Re: Beacon Park Subdivision Concept/Use On Review (File # 5-SE-06-C, 5-H-06-UR).

Re: May 11, 2006 Metropolitan Planning Commission Meeting – Minutes Correction and Response to Comments - Beacon Park Subdivision Concept/Use On Review (File # 5-SE-06-C, 5-H-06-UR).

ATTACHMENT I

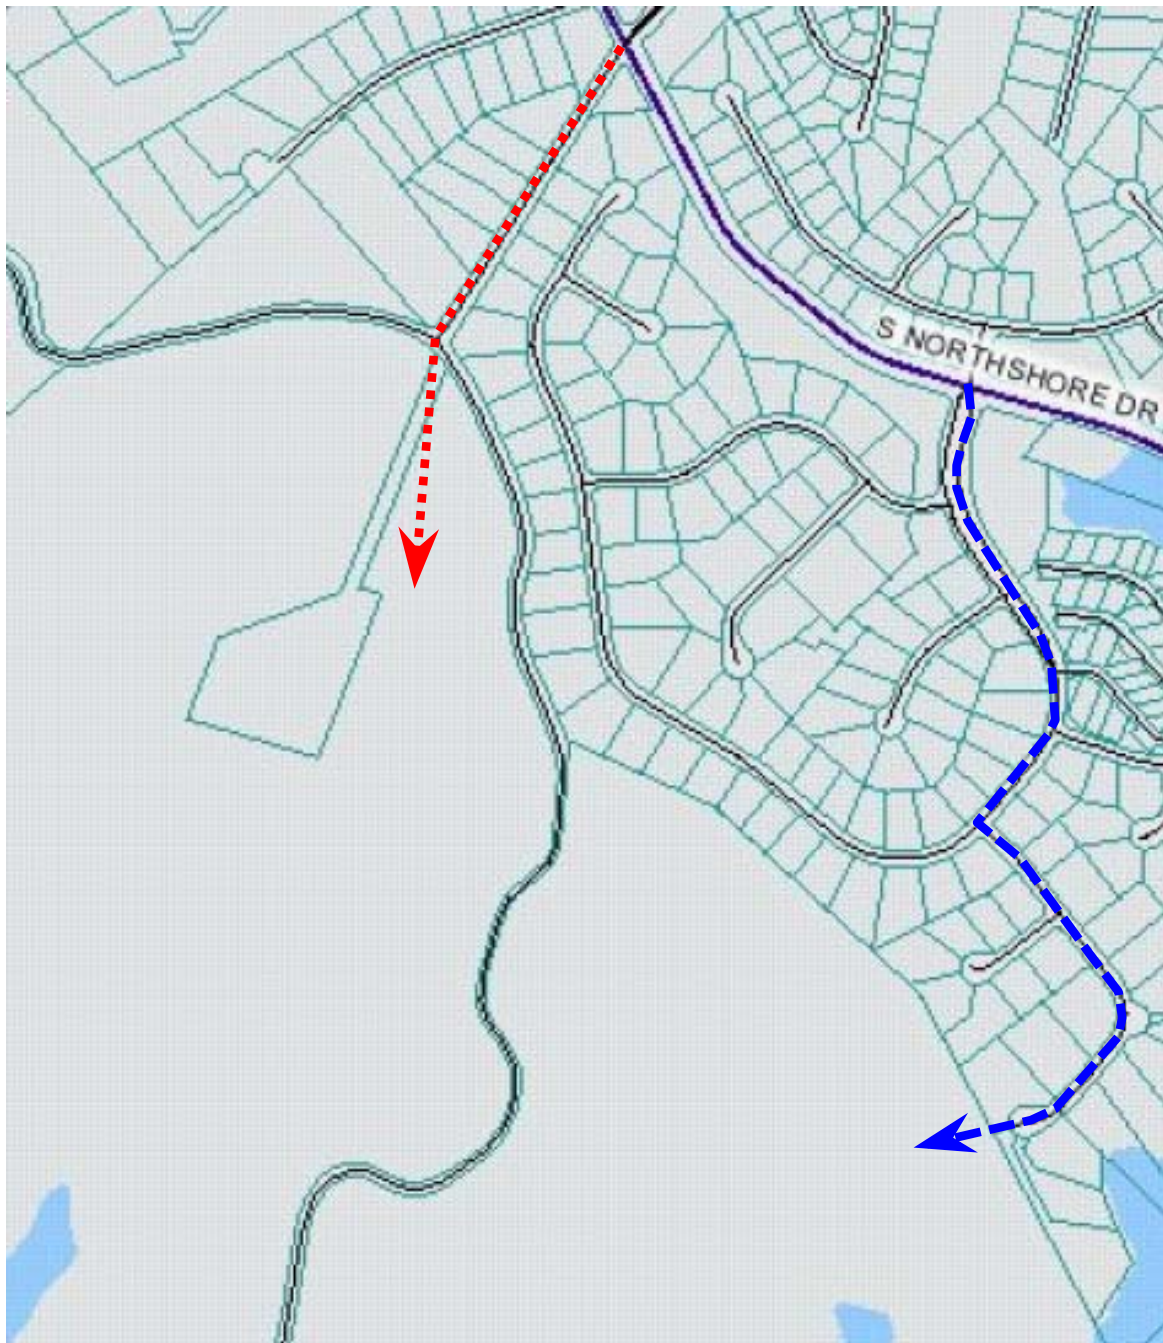
Also, in response to my questions and concerns regarding the plan for only one entrance into this proposed 800+ development, Dan Kelly indicated that his department had some of the same concerns. Mr. Kelly stated that the only way onto the property besides Chandler Road was to build a bridge from Blount County across Fort Loudon Lake. I believe that Mr. Kelly was exaggerating the access limitations. Attachment I of this letter presents a map of the area showing not only the proposed access by way of Chandler Road but an equally viable alternate access way through Riversound Subdivision by way of Thimble Field's Drive. The incorporation of this second entrance into the development will improve traffic flow and public safety considerations by providing alternate access for the residents, maintenance service personnel, and emergency services personnel. Furthermore, the county roadways through the Riversound subdivision are already at least 20 feet wide with a more than adequate divided boulevard at the entrance with turn-, acceleration-, and deceleration-lane accommodations on Northshore Drive.
